IN THE DRAWINGS:

REMARKS:

Careful consideration has been given to the Official Action of September 23, 2004 and reconsideration of the application as amended is requested.

FIG. 3

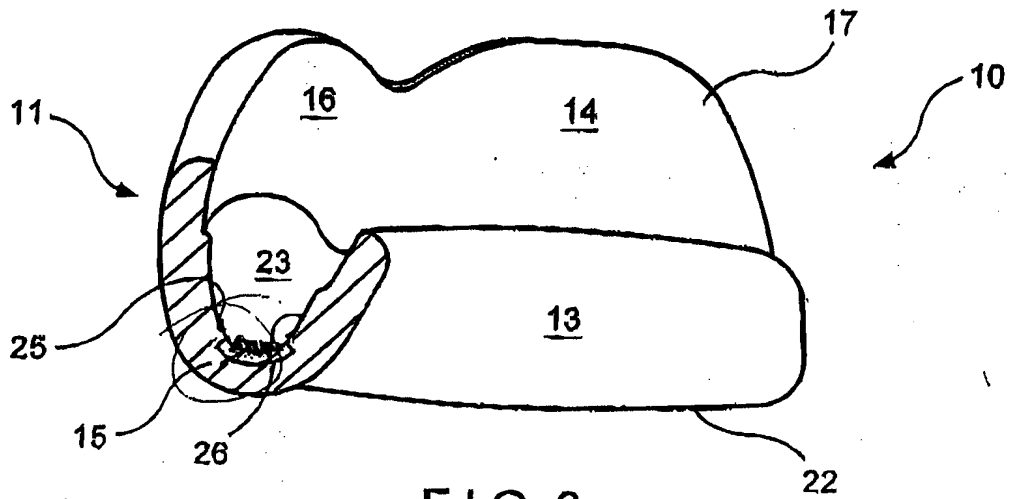
The lead line for numeral 26 has been redrawn in Fig. 4 to designate the thickened portion, whose extent is now also shown in Fig. 4. In Fig. 3, the thickened portion 26 is also shown. Figs. 3, 4, and 8 are now consistent.
